)	
)	
In the matter of:)	
)	
Notice of Proposed Rulemaking)	
The New York North Shore)	Docket No. FAA-2010-0302
Helicopter Route)	
)	
)

Comments of the Eastern Region Helicopter Council

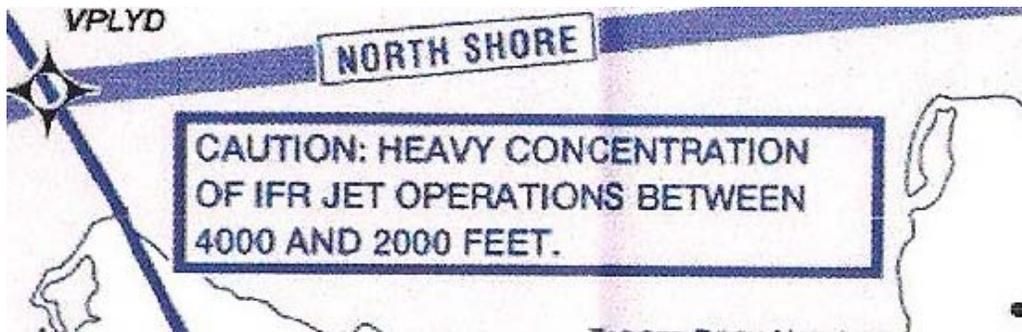
Fifth, the NPRM inappropriately, and potentially unsafely, mixes VFR and IFR operations by concentrating uncontrolled traffic at an altitude and in a location already rife with commercial jet traffic flying into the major airports in the region. The current chart for the voluntary NSHR contains the following warning to helicopter pilots of heavy aircraft traffic between 2,000 and 4,000 feet (and adjacent to the initial GPS waypoint for the NSHR):

Making the NSHR mandatory without controlled airspace with active ATC for separation would result in mixing ATC-controlled IFR traffic with non-controlled VFR traffic, which raises significant operational and safety concerns. Making the NSHR mandatory for VFR operations based on unquantified noise complaints alone, with no regard for the significant safety concerns at stake, would be imprudent and unjustified.
